Economic Commission for Europe**Inland Transport Committee****World Forum for Harmonization of Vehicle Regulations****Working Party on General Safety Provisions****126th session**

**Awareness of the Proximity of Vulnerable Road Users:
UN Regulation No. 46 (Devices for indirect vision)****Proposal for the 06 of amendments to UN Regulation No. 46
(Devices for indirect vision)****Submitted by the expert from Germany on behalf of the Task Force on
UN Regulation No. 46 ***

- (i) Edge of the reflecting surface enclosed in a protective housing
- (ii) Reflecting surface projects beyond the protective housing in a specific adjustment position
- (iii) Edge of the reflecting surface not enclosed by the protective housing

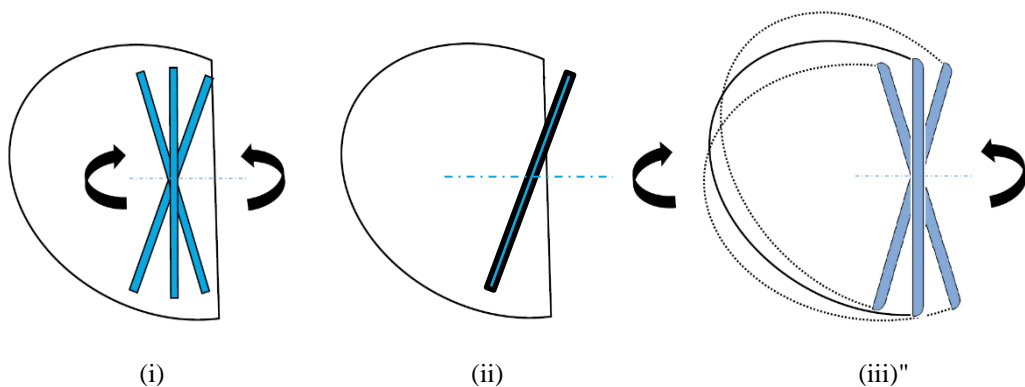
When the edge of the reflecting surface is enclosed in a protective housing, the radius of curvature "c" on the housing's perimeter shall be not less than 2.5 mm at all points and in all directions, figure below (i).

When ~~If~~ the reflecting surface projects beyond the protective housing **in any adjustment position (figure below (ii))**, the radius of curvature "c" on the edge of the projecting part shall be not less than 2.5 mm and the reflecting surface shall return into the protective housing under a force of 50 N applied to the point of greatest projection, relative to the protective housing, in a horizontal direction, approximately parallel to the longitudinal median plane of the vehicle.

When the edge of the reflecting surface is not enclosed by the protective housing independent from any adjustment position, the radius of curvature "c" on its perimeter shall be not less than 2.5 mm at all points and in all directions and shall apply to the edge of the projecting part, figure below (iii).

Figure 9.1

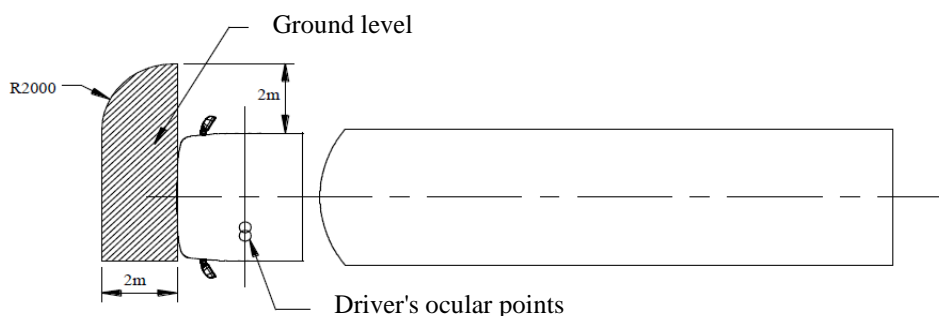
"15.2.4.6.1. The field of vision shall be such that the driver can see at least a flat horizontal portion of the road, which is **for side-steered vehicles** bounded by:

- (b) a transverse vertical plane 2,000 mm in front of the plane defined in (a);
- (c) a longitudinal vertical plane parallel to the longitudinal vertical median plane going through the outermost side of the vehicle at the driver's side; ~~and~~
- (d) a longitudinal vertical plane parallel to the longitudinal vertical median plane 2,000 mm outside the outermost side of the vehicle opposite to the driver's side; **and**
- (e) ~~The~~ **the** front of this field of vision opposite to the driver's side may be rounded off with a radius of 2,000 mm (see Figure ~~9~~ **9.1**).

Figure 9, renumber as Figure 9.1. and amend to read:

"Figure 9.2

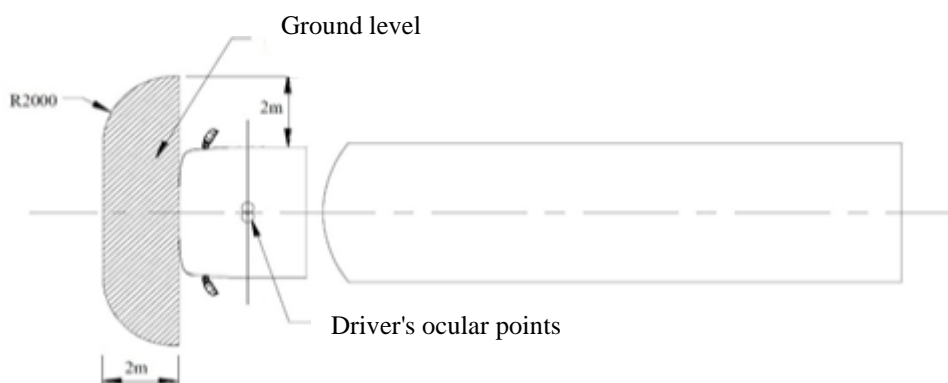
The field of vision shall be such that the driver can see at least a flat horizontal portion of the road, which is for centre-steered vehicles bounded by:

- (f) **A transverse vertical plane through the outermost point of the front of the vehicle;**
- (g) **a transverse vertical plane 2,000 mm in front of the plane defined in (a);**
- (h) **a longitudinal vertical plane parallel to the longitudinal vertical median plane 2,000 mm outside the outermost side of both sides of the vehicle; and**
- (i) **the front of this field of vision on both sides may be rounded off with a radius of 2,000 mm (see Figure 9.2).**

Insert a new figure 9.2., to read:
